HISTORIC LANDMARK COMMISSION
APPLICATION FOR A PERMIT WITHIN A NATIONAL REGISTER HISTORIC DISTRICT
AUGUST 24, 2020
HR-20-107348
319-323 E. 6TH STREET
SIXTH STREET NATIONAL REGISTER HISTORIC DISTRICT

Construct a two-story addition to three contributing buildings within the Sixth Street National Register Historic District.

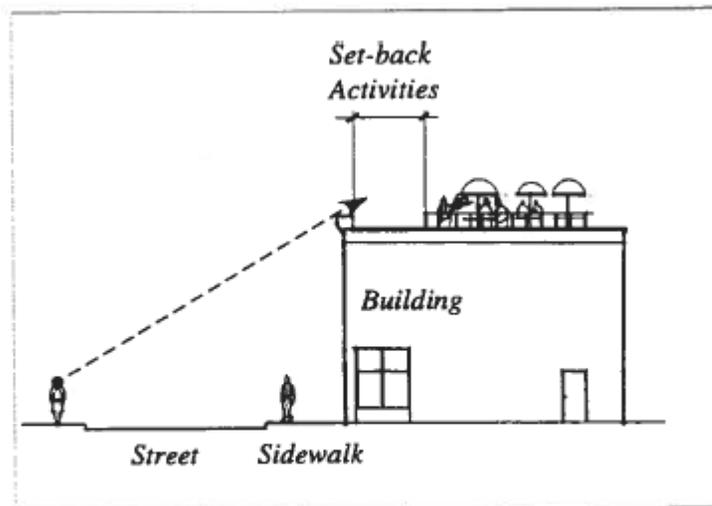
The proposed project does not conform to the applicable guidelines of the Secretary of the Interior nor the Architectural Design Guidelines in that it is too close to the front of the one-story buildings, and has high potential to be visible from the sidewalk across the street. However, the proposed addition is well-designed and compatible with the ground-story architecture in terms of scale, massing, and materials.

Encourage the applicant to pull back the front of the addition and the decks to at least 15 feet, which will further minimize the visual impact of the proposed project on the historic one-story buildings at its base. Staff recommends that the Commission provide additional comments and release the permit upon completion of a City of Austin Documentation Package, consisting of photographs of the principal elevations.
